651S-1
GENERAL PURPOSE HF RECEIVER

PUB NO.	NOTE	DATE	SUBJECT
IB 1-72 ✓		03/01/72	Subassembly Interchangeability
SB 1		10/01/72	Reduction of 450-kHz Leakage From Synthesizer Reference Board All
SB 2		06/06/73	Reduction of Noise Level
SB 3		07/15/73	Add Keep-Alive Frequency Memory Function
SB 4		07/15/73	Extend Comma and Decimal Lamp Life in Frequency Display
SB A ✓		11/01/73	Change DCFE Filter Switching Diode
SB 5	1	12/15/74	Minimize TCU Circuit Card Response to Data Link Noise and Failure
SB 6	2	03/01/75	Reduce Intermodulation Level
SB 7		02/07/75	Reduce Internal Spurious Signals
SB 8		12/27/74	Allow Remote Control Operation With RS-232C Serial Control Interface Card A9
SB 9 ✓		02/15/75	Increase Life of Display Tubes
SB 10 ✓	2	12/31/75 Revised 08/02/76, 04/01/77	Replacing Display Tubes With LED Plug-in Assemblies
SB 11		Not issued	
SB B ✓		11/15/74	KAV
SB C ✓		01/15/78	Supply KAV Power to DCFE
SB 12 ✓		05/01/78 Revised 07/01/78	Replacing Nonprocurable Integrated Circuits

SERVICE BULLETIN A

SUBJECT: Change DCFE Filter Switching Diode

651S-1 Sideboard, Bottom View, Connector Locations
Figure 2

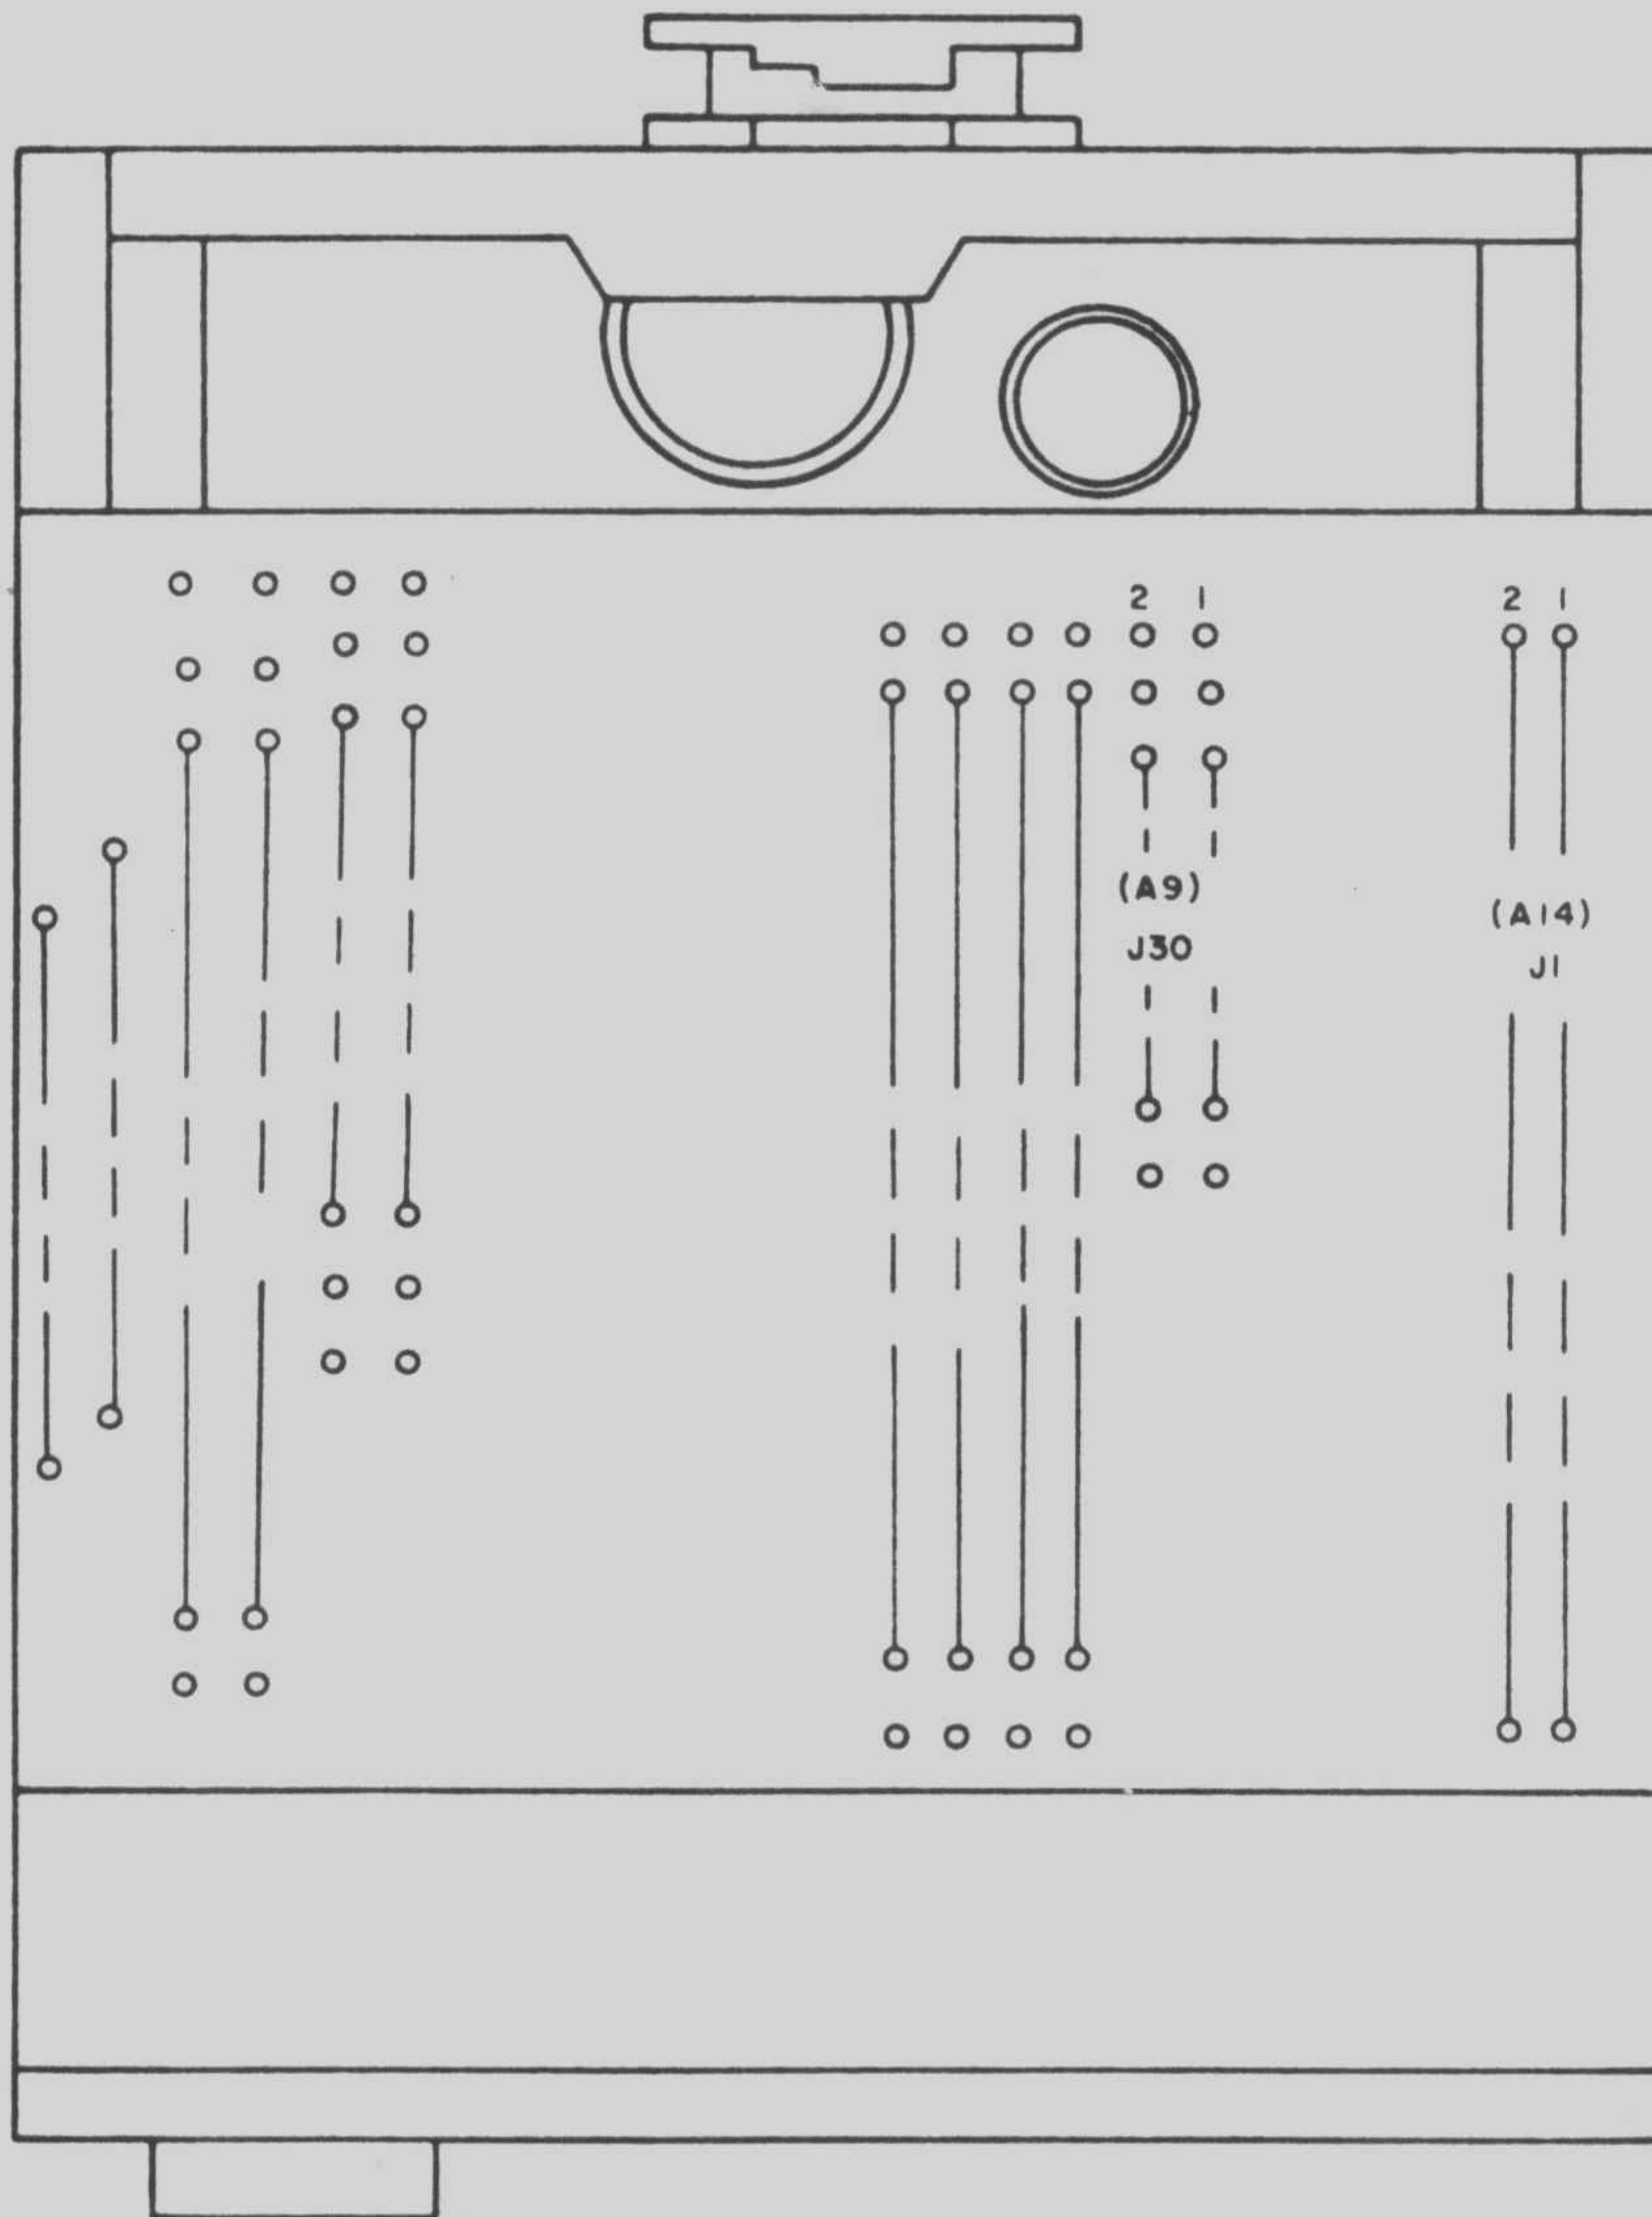
- f. Wrap and solder the other end of the jumper around the contact lead of socket 22.
- g. Mark "SB B" on the TCU card near the part number.
- h. On the bottom of the 651S-1 chassis sideboard, connect a jumper (428-4821-000) from J1-17 (mates with A14 connector) to J30-22 (mates with A9 connector). Refer to figure 2.

P/O DC FE Circuit Card A8, Connector Pin Locations
Figure 1

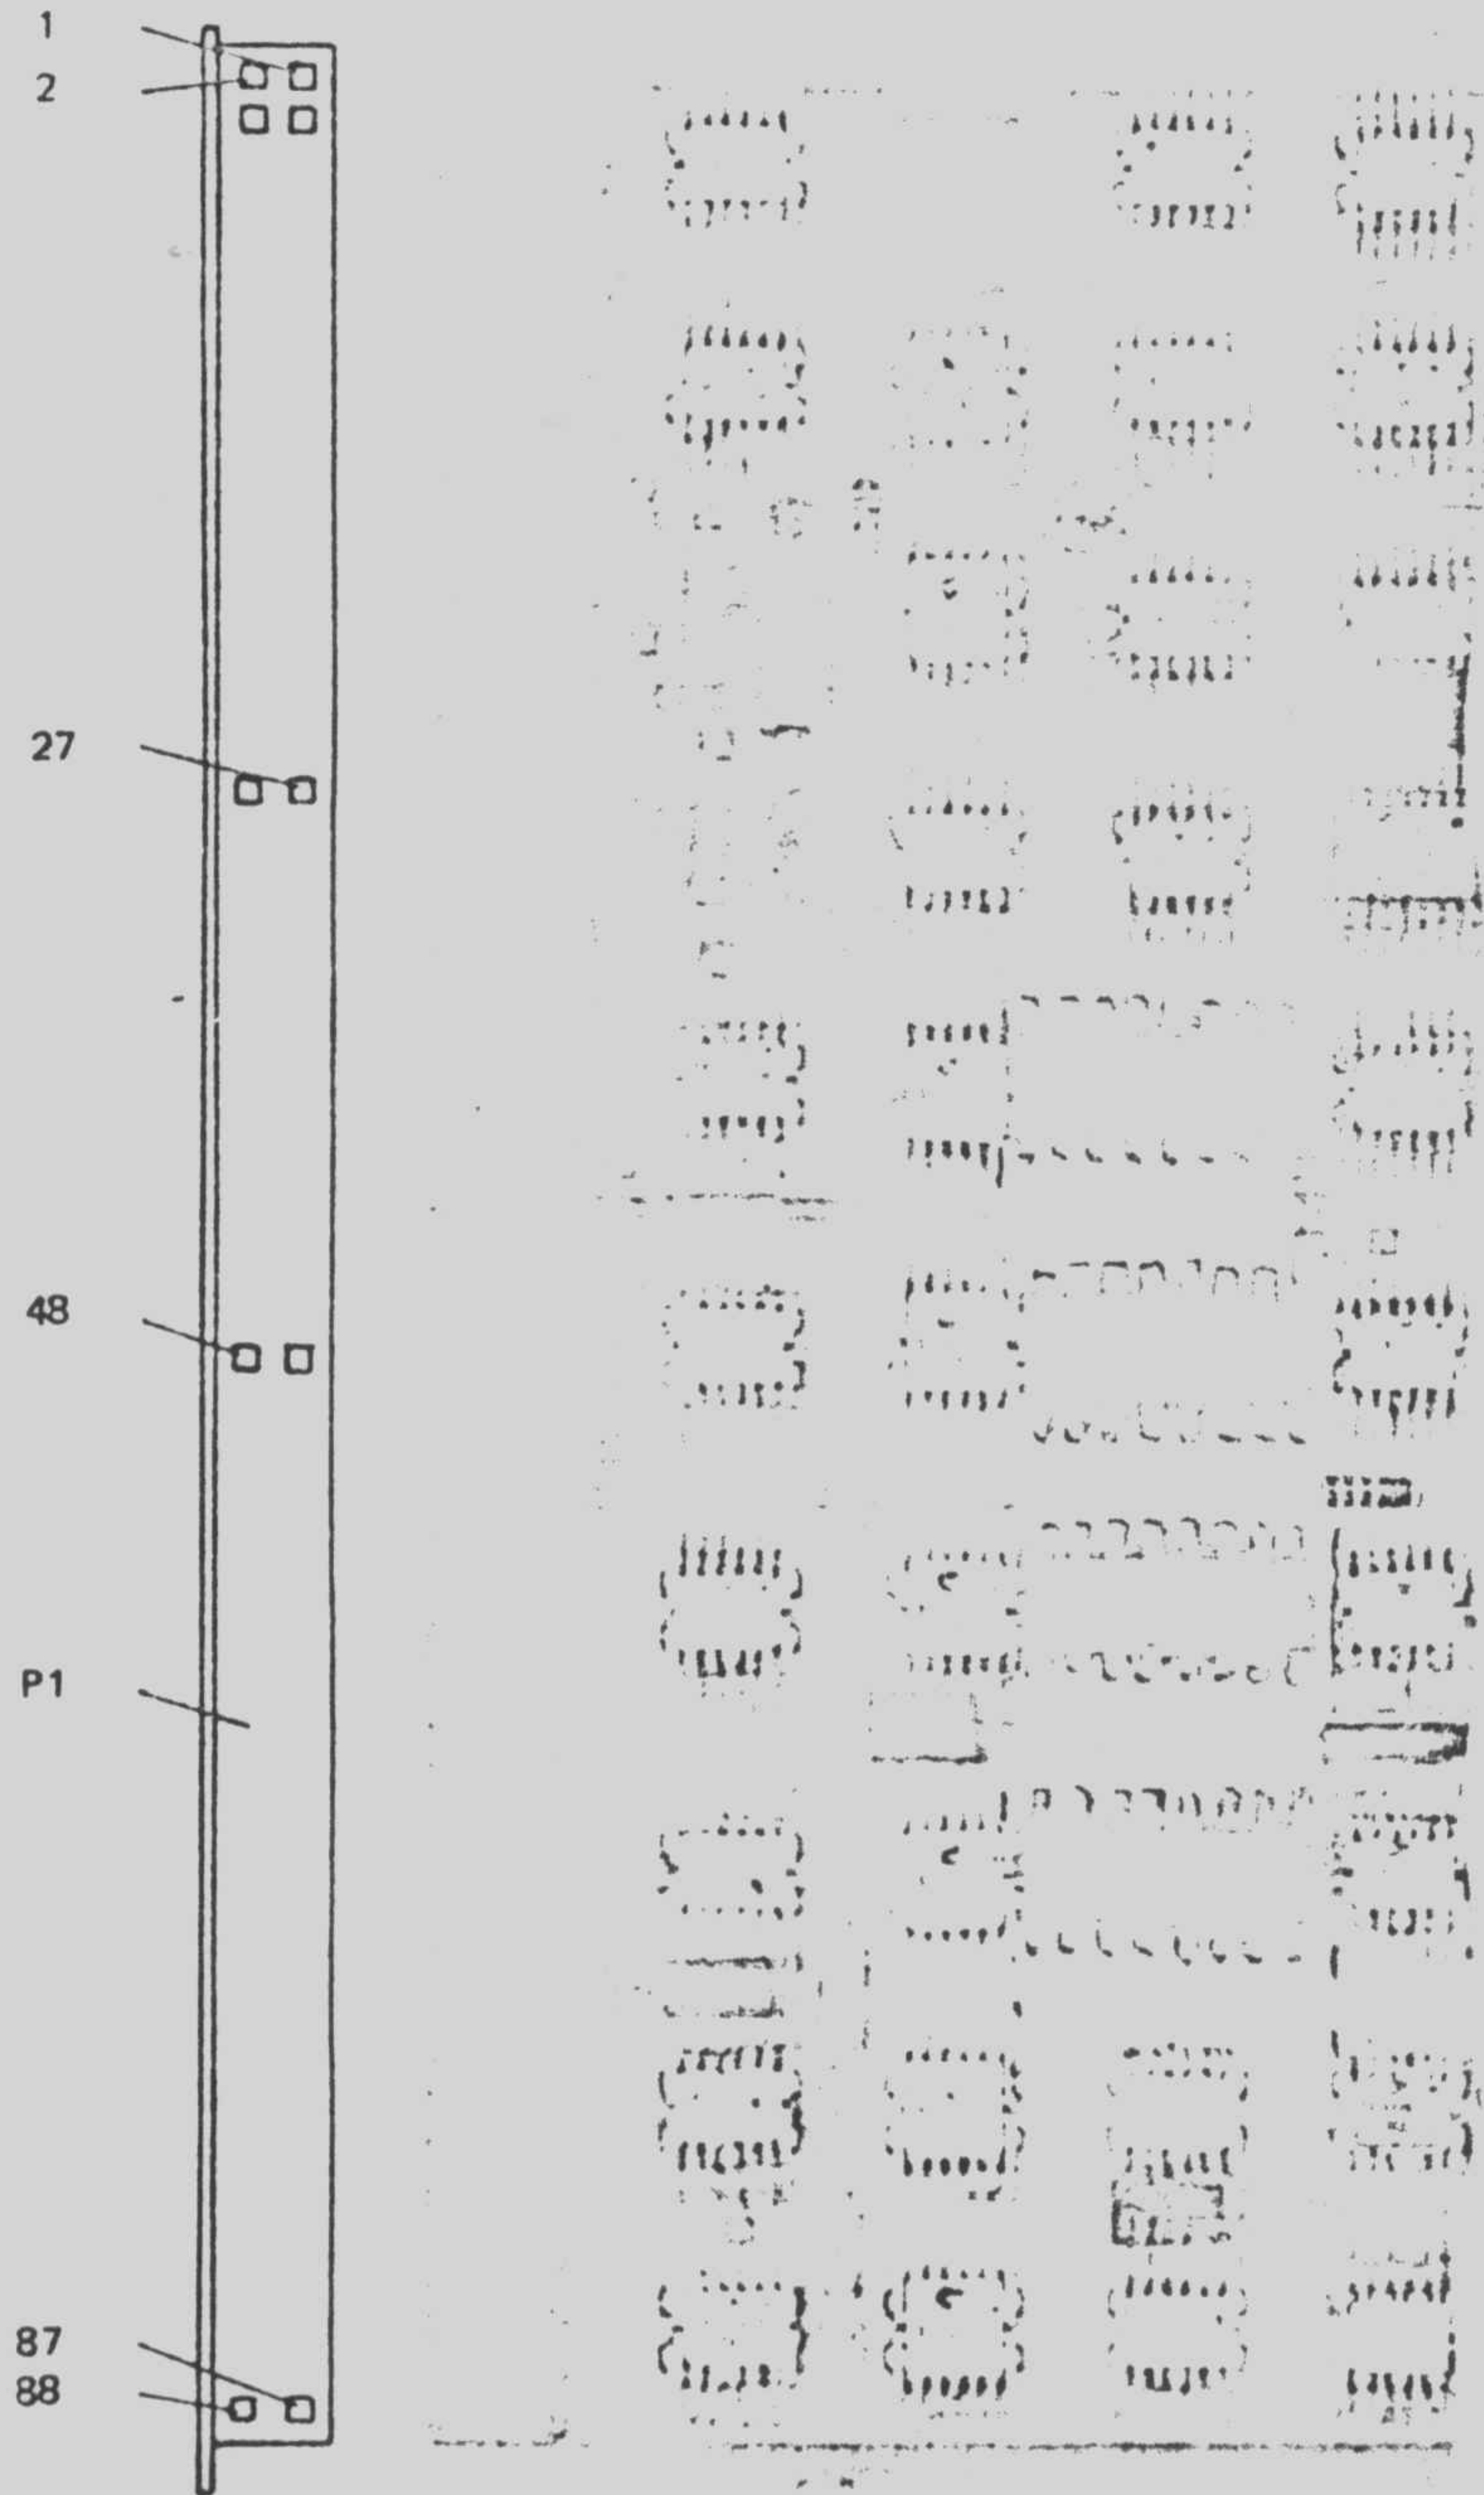
- B. Remove the DC FE circuit card A8, CPN 624-5744-001, from the receiver.
- C. Disconnect +5-volt power by removing contact P1-27 from the blue line connector on the card. Refer to figure 1.
- D. On the back of the card, connect a #26 insulated bus wire (422-4008-000) from the vacated hole at P1-27 to spare contact P1-48.
- E. Mark "KAV OPERATION" near the part number on the card.
- F. On the receiver sideboard, connect a #26 insulated bus wire (422-4008-000) from XA8-48 to XA9-22 to provide keep-alive power to A8. Refer to figure 2.
- G. Reinstall DC FE card in receiver.
